SUBMISSION TO SYDNEY OLYMPIC PARK MASTERPLAN (2016 REVIEW) AND AMENDMENTS TO SEPP (STATE SIGNIFICANT PRECINCTS) 2005

The subject site is located at 6 Figtree Drive, Sydney Olympic Park and is also identified by SOPA as Site 51. The site covers a total area of 11,716 sqm and is currently home to the NSW Institute of Sports.

Diagram 6

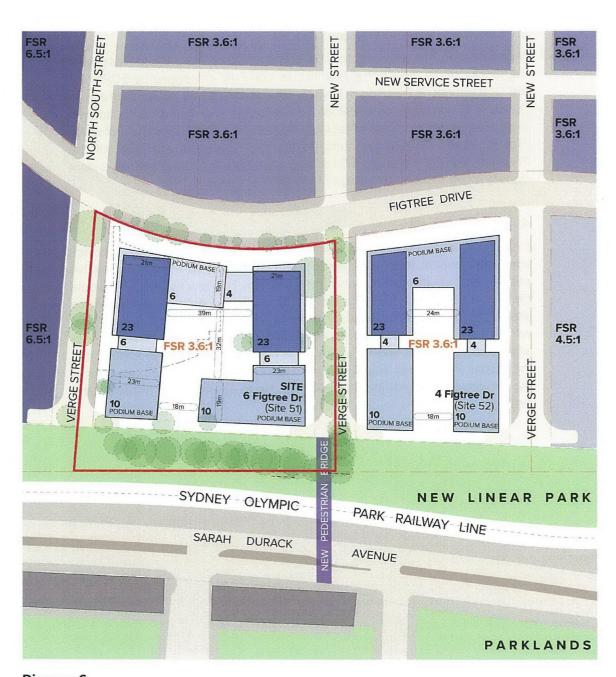
As the accompanying drawings by Turner show, the site potential of 6 Figtree Drive to accommodate density, is considerable. An FSR of 3.2:1 represent a missed opportunity to facilitate density at appropriate locations and unduly restricts the Site's capability to provide future growth. We consider an FSR of 3.6:1 to be more appropriate for the Site.

In terms of building design, an FSR of 3.6:1 could be readily achieved, whilst also complying with all the relevant development controls. This includes building separation, setback and the tower-profile criteria required for new residential block developments. In addition, all new development incorporating this FSR could be designed such that any off-site impacts can be fully mitigated, including any impact upon existing or future neighbouring buildings. Refer to Diagram 6.

An increase in FSR provision to 3.6:1 would reinforce the desired massing of the blocks within the Central Precinct, as currently envisaged by SOPA and the Department of Planning & Environment. As illustrated by Turner (refer to Diagram 6), the proposed FSR of 3.6:1 is in line with overall development principles, as set out for the Precinct and creates a more desirable outcome. The proposed FSR better compliments the residential character of the Precinct, with the increased FSR providing a more improved and consistent density along the southern edge of the Central Precinct.

Future Masterplan controls can accommodate FSR of 3.6:1 within height controls to match FSR set for adjacent sites for consistency across the Precinct.

Diagram 7

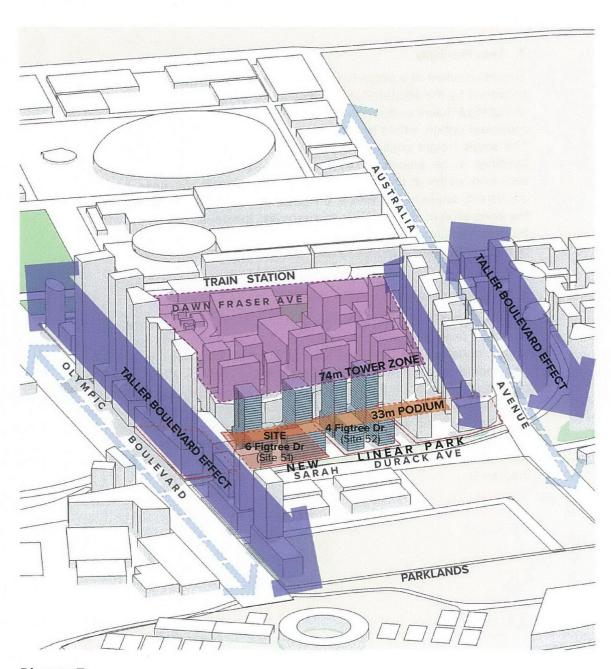
Whilst the increase in the height control on part of the site is welcomed and aligns with the updated strategy in the Master Plan, the introduction of a split control across the site, is not in our view, conducive to good architectural outcomes.

Our view is that a single height control across both Site 51 and Site 52, will create a consistent and improved architectural outcome for the Precinct. This can easily be achieved by simply setting the height limit at 74m for the entire site.

The introduction of a split level control is considered to be detrimental to achieving better architectural outcomes. This is particularly the case where all other blocks across the precinct, apart from the two blocks to the south of Figtree Drive, which have been allocated a single, height limit restriction (refer Diagram 7 overlef).

Split height controls (of 33m and 74m) limits variety to architectural, scale and form on Sites 51 and 52.

Diagram 8

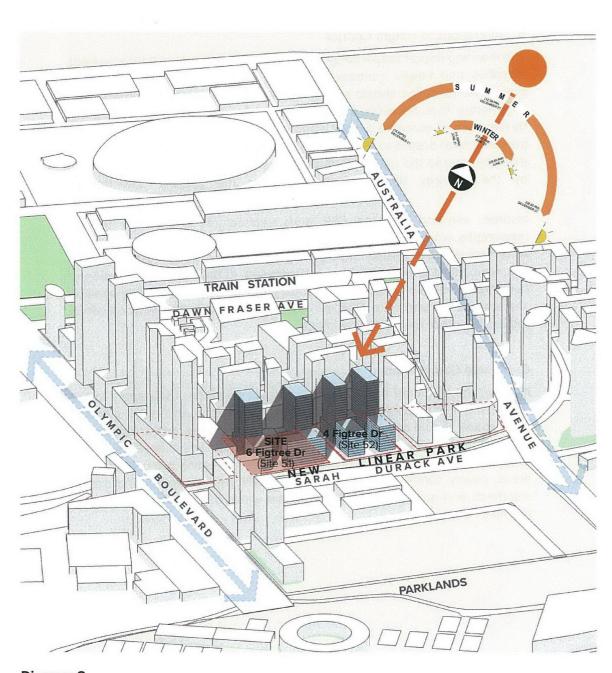
This form of height control introduces an avoidable constraint on the future design of any building at the Site. Turner have prepared a set of illustrative plans which demonstrate that appropriate massing is better achieved without these artificial, split-level controls at the Site. Single controls are more logical and would better serve the Master Plan principles for the precinct, without the need for restrictive and introduced complexities to height control. Refer to Diagrams 8, 9 and 10.

Taller buildings to the north overshadow lower buildings to the south, counter intuitive to ADG objectives for solar & daylight access.

Diagram 9

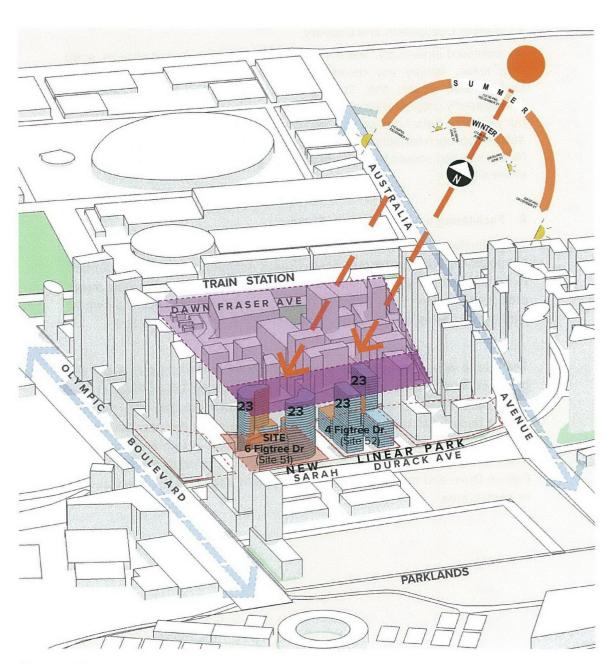
The introduction of a single height control across the Site at 74 m (as partly proposed by the Master Plan) would allow a greater degree of flexibility in designing all future built-form at the Site. It is our view and that of Turner, that this proposed option, would facilitate better architectural and design outcomes. The single height control would increase flexibility and would allow taller buildings to be placed more appropriately across the block. This would also work better at the interface with the linear park and views beyond. A consistent, single height limit at 6 Figtree Drive, would also greatly assist in the integration of the on-site open space into the development, allowing it to be better assimilated into the overall Masterplan for the Park and provide a better architectural response to Site features. Refer Diagram 9 and 10.

If greater flexibility was afforded to the design, a new tower on the Site, for example, which is taller at the southern part of the Site would better avoid any shadowing at the Site and its surrounds. This should be strongly considered on amenity grounds alone, as it would be highly beneficial for the amenity levels of surrounding future residents. It would also help to create a more sympathetic built form that is much more consistent with the overall character of Figtree Drive. Such flexibility to the height controls, would better reflect and reinforce the designated view corridors, as set out in the exhibited Master Plan across Olympic Park. Refer Diagram 9.

Provision of a single height limit (of 74m) across the site provides flexibility for improved solar access and variety of bulk and scale in response to the surrounding context.

Diagram 10

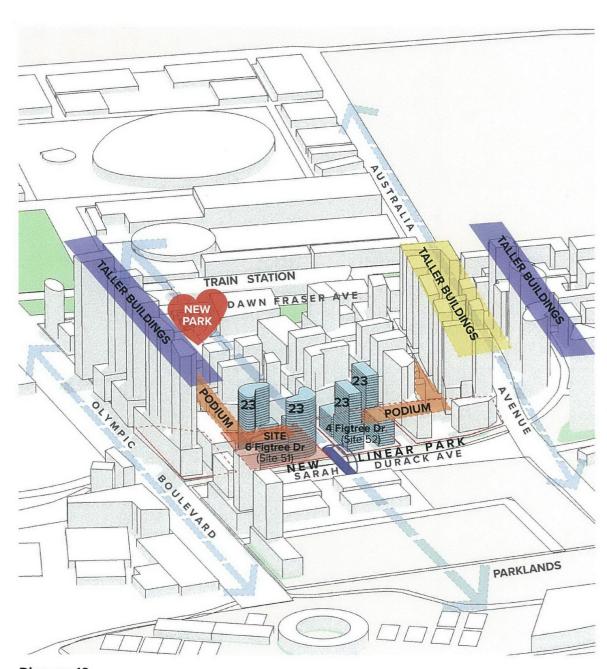
We understand from communications with SOPA to date, that a new pedestrian connection is proposed across Sarah Durack Avenue. This bridge is intended to land immediately to the east of the site, in proximity to the new street proposed between Sites 51 and 52 within the Central Precinct. Diagram 10 overleaf ,identifies the positioning of the bridge in relation to the Site.

The bridge will serve to create a key nodal point at this location, which will better connect the Central Precinct with the Boundary Creek Precinct and accommodate future pedestrian flows. Such a solution would fit far better with a taller building across the Site and will better address the new pedestrian bridge and provide a 'sign-posting' development as a reference point for future bridge users. This will bring additional new opportunities to both 6 Figtree Drive and the area, linking the southern portion of the Precinct with its central area.

Taller building forms adjacent to the new pedestrian bridge reinforces the north-south connection to the town centre.

Diagram 12

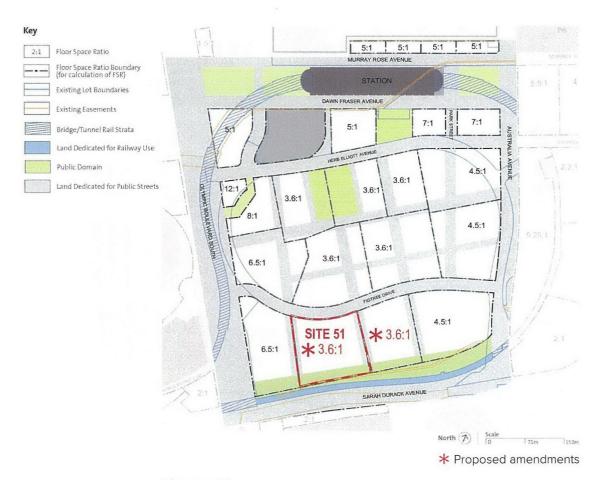
An FSR control of 3.6:1 should be implemented at Site 51. This would continue the density controls from the central section of the precinct, facilitating better and earlier outcomes whilst not undermining the massing or development principles of the precinct. This approach would also accord with the overall strategy within the Master Plan.

Diagram 15

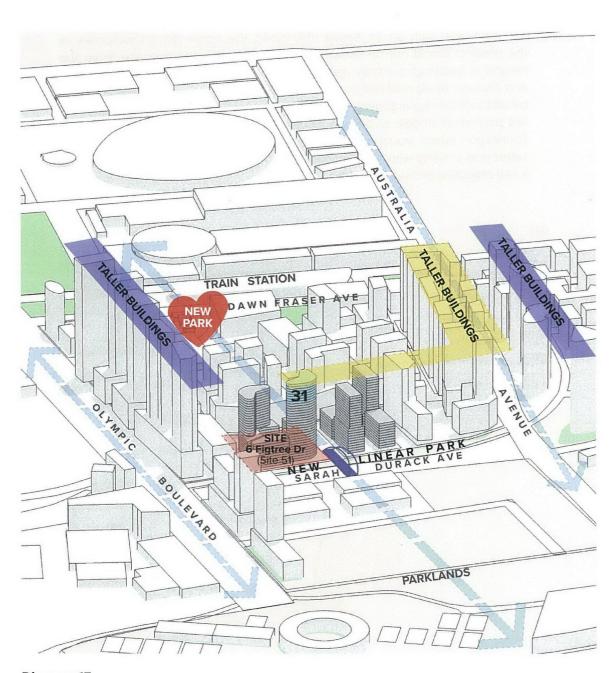
There exists an opportunity to facilitate a greater FSR at Site 51, beyond the level previously discussed within this document. This arises from the desired new pedestrian footbridge across Sarah Durack Avenue, which would land between Sites 51 and 52, and would link the Boundary Creek Precinct to the south with Parkview Precinct and the town centre to the north. Refer Diagram 15.

Through this alternate future option proposal, our client believes that there is an opportunity to assist SOPA in expediting the delivery of the planned footbridge across Sarah Durack Avenue. Our suggestion to SOPA, is that a future agreement could be reached which facilitates the part funding of the bridge, beyond the existing contribution framework which is in place, derived from development contributions resulting from the development of greater FSR at Site 51. Any additional contributions would need to be reasonable and proportionate to the site and its physical and functional attributes, but an FSR of 4.0:1 for example, can easily be accommodated, according to our studies (refer Diagram 15 overleaf).

Additional height adjacent to the new pedestrian bridge reinforces the north-south connection to the town centre, consistent with planning objectives.
